Carrickmines-Shanganagh River Flood Relief Scheme

EIAR – Addendum Report

This EIAR Addendum has been prepared in response to a Request for Further Information (RFI) from An Coimisiún Pleanála (ACP) on the 15th December 2025 in relation to the proposed Carrickmines-Shanganagh River Flood Relief Scheme (CFRS). The planning application, which included an EIAR for CFRS, was submitted to ACP on the 20th February 2025, ACP Ref. No. 321937. The ACP request sought additional information by way of an EIAR Addendum to several chapters of the EIAR.

Figure 8-2: Belarmine habitats

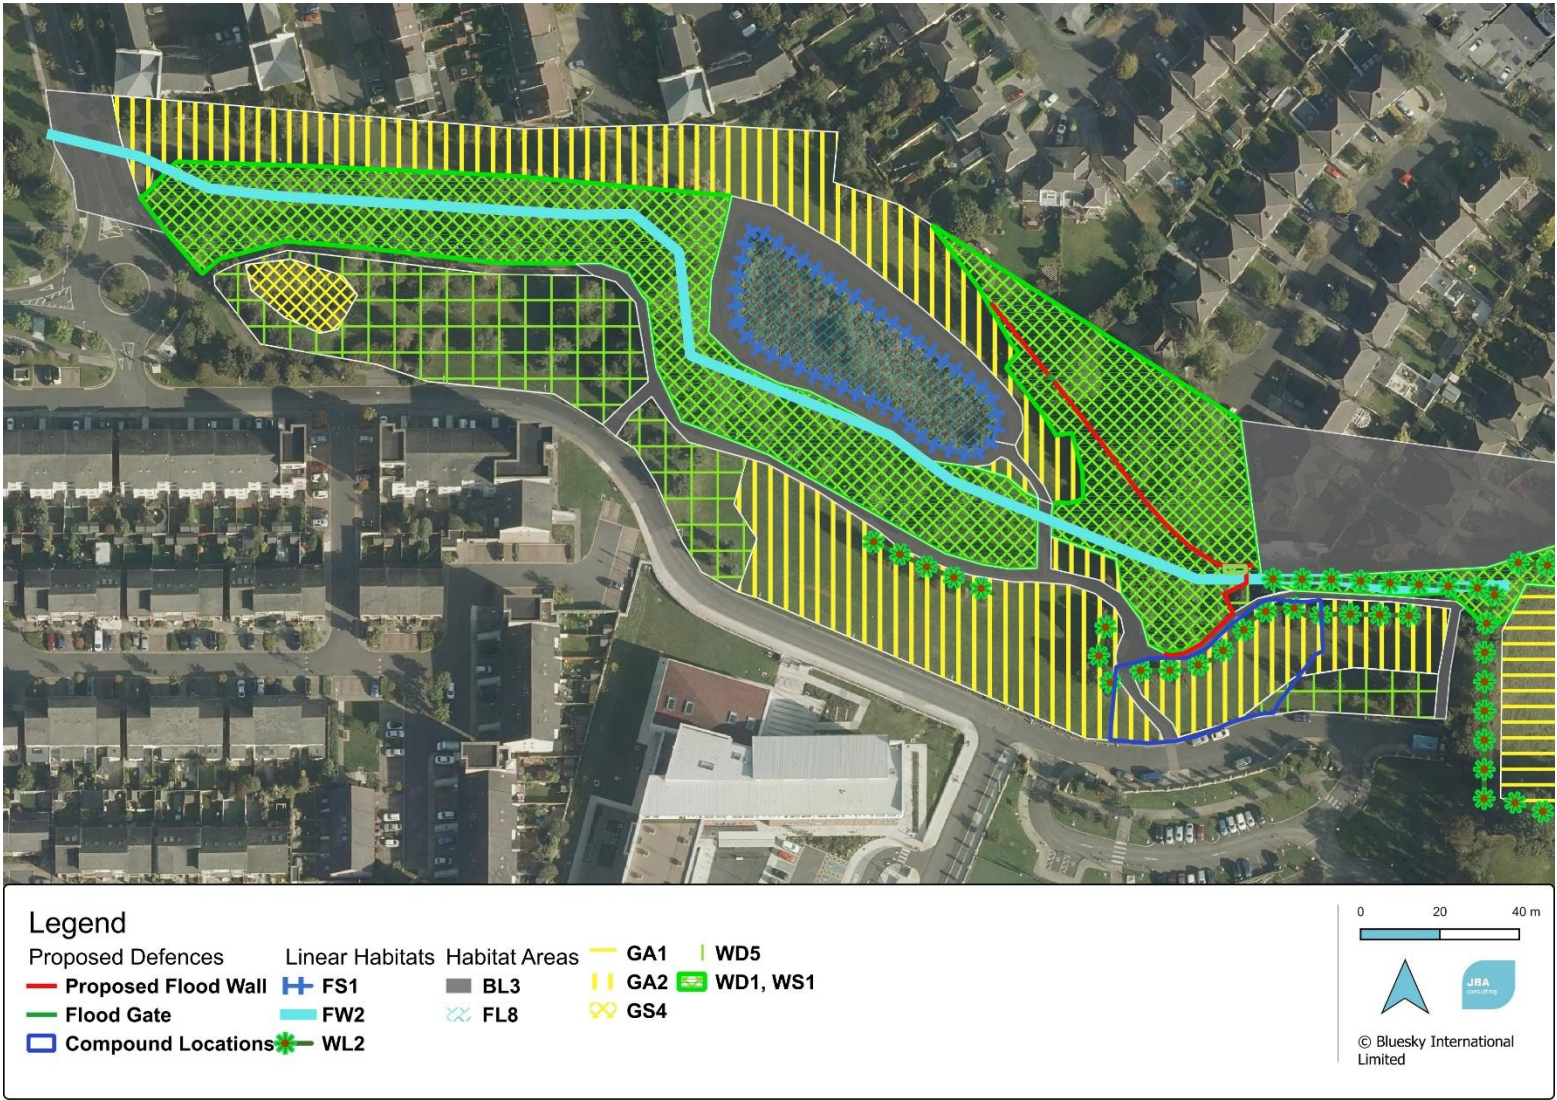
“Clarify if all compound areas and any temporary access wayleaves were surveyed for flora and fauna, including invasive species. Provide updated habitat and IAS maps where necessary, encompassing all lands within the red-line boundary, compound areas and any temporary wayleaves. “

Updated habitat mapping has been prepared to address the matters raised in the above RFI item. The updated mapping encompasses the lands within the red-line boundary, including the proposed compound areas and temporary access wayleaves. The updated habitat maps are provided in Figures 8-1 to 8-7 below.

Figure 11-4: 24 Hours Background Traffic Flows at Glenamuck Road North – West Arm (Eastbound Traffic Lane) on Glenamuck Road North Roundabout in 2029 (with additional 8% factor of safety)

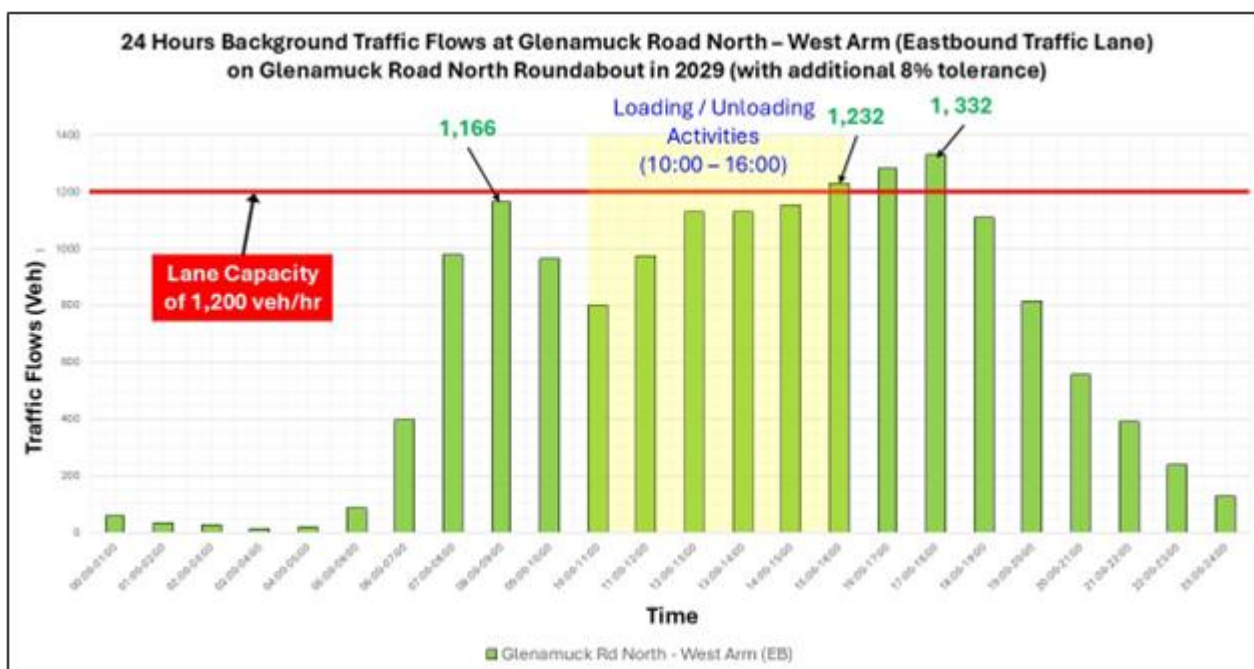
ACP Item	Comments	Responses
12a	It is considered necessary that the EIAR is updated by way of Addendum to account for the additional information including the traffic assessment submitted in the Response to Submissions Documentation.	A new traffic count survey was undertaken (refer to Section 11.3.2) to facilitate the traffic assessment at Glenamuck Road North (refer to Section 14.4.1(3)) and the N11 Overflow Culvert (refer to Section 14.4.1(4)).
12b	For the purposes of clarity submit an additional cross section east to west, along Carrickmines River, traversing Glenamuck Road North (R842) and capturing the proposed works either side of Glenamuck Road North.	An additional cross section has now been provided on drawing number 20108-JBB-00-XX-DR-Z-02945 and is included as part of the response to ACP.
12c(i)	Notwithstanding, that a CTMP will be prepared, the response to the concerns raised by the NTA are considered inadequate.	At Glenamuck Road North, a 1.8m wide temporary access route will be provided as part of the traffic management to maintain pedestrian and cycle movements adjoining the works area. Separate access routes for pedestrians and cyclists are not possible due to spatial constraints, thereby requiring access route to be shared. Given the vulnerability of pedestrians' relative cyclists, it is best practice and the safest option for cyclists to dismount to utilise this shared access route. It is our view that moving cyclists onto the road network to share access with vehicles is not an option as it alters the existing condition in the area, whereby cyclists have their own designated lane. At Commons Road and Kilgobbin Road cyclists will be expected to adhere to the existing situation as no designated cycle lanes exist. In this case, we just continue with the normal traffic flow through the management systems. A designated pedestrian route will be provided through the works areas at these locations as part of the traffic management plan.

With reference to Figure 11-4, it is anticipated that the highest background traffic flows in 2029 at Glenamuck Road North – West Arm (Eastbound traffic lane) on Glenamuck Road North Roundabout between 10:00 and 16:00 will be 1,232 vehicles at 15:00-16:00, which is level that slightly exceeds the aforementioned lane capacity of 1,200 vehicles per hour under this conservative assessment. However, the proposed loading / unloading activities at Glenamuck Road North will only be carried out intermittently and for short duration periods. The appointed Contractor shall be required to apply strict traffic management procedures which shall be overseen by the Employers Representative. Considering the above data and the application of strict and professional Traffic Management to the works, it is anticipated that the proposed loading / unloading activities at Glenamuck Road North during the off-peak hour (i.e. 10:00-16:00) will not cause a significant

Figure 16-1: Other projects considered, Clon Brugh to Kilgobbin Road

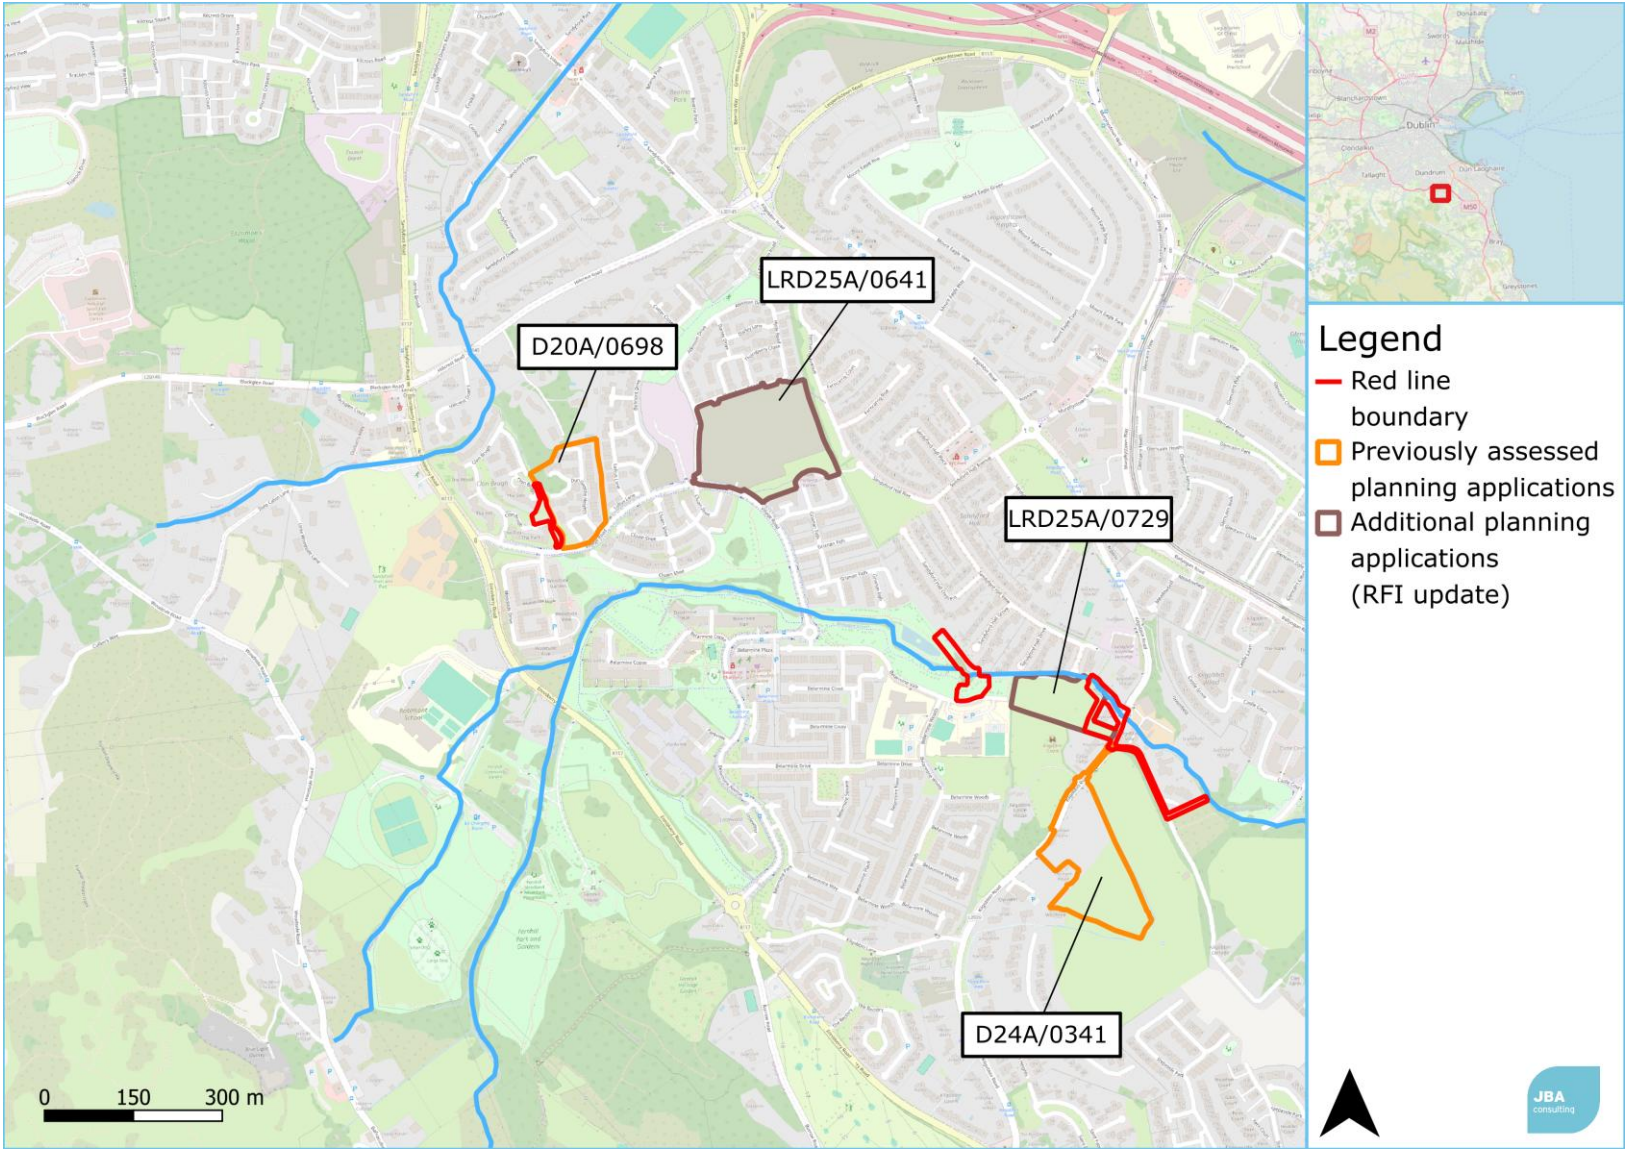
The cumulative impact assessment has been revised to take account of any additional projects identified since the EIA submission in 2025. The potential for cumulative effects with these projects has been assessed and is presented in this chapter.

Planning Application LRD25A/0729 proposes the construction of 120 no. apartment units on Kilgobbin Road via Belarmine Vale, partially overlapping with the site area of the proposed development, and has been granted permission. If this project goes to construction at the same time as the proposed development, there is potential for impacts with regard to construction traffic and disruption along Kilgobbin Road.
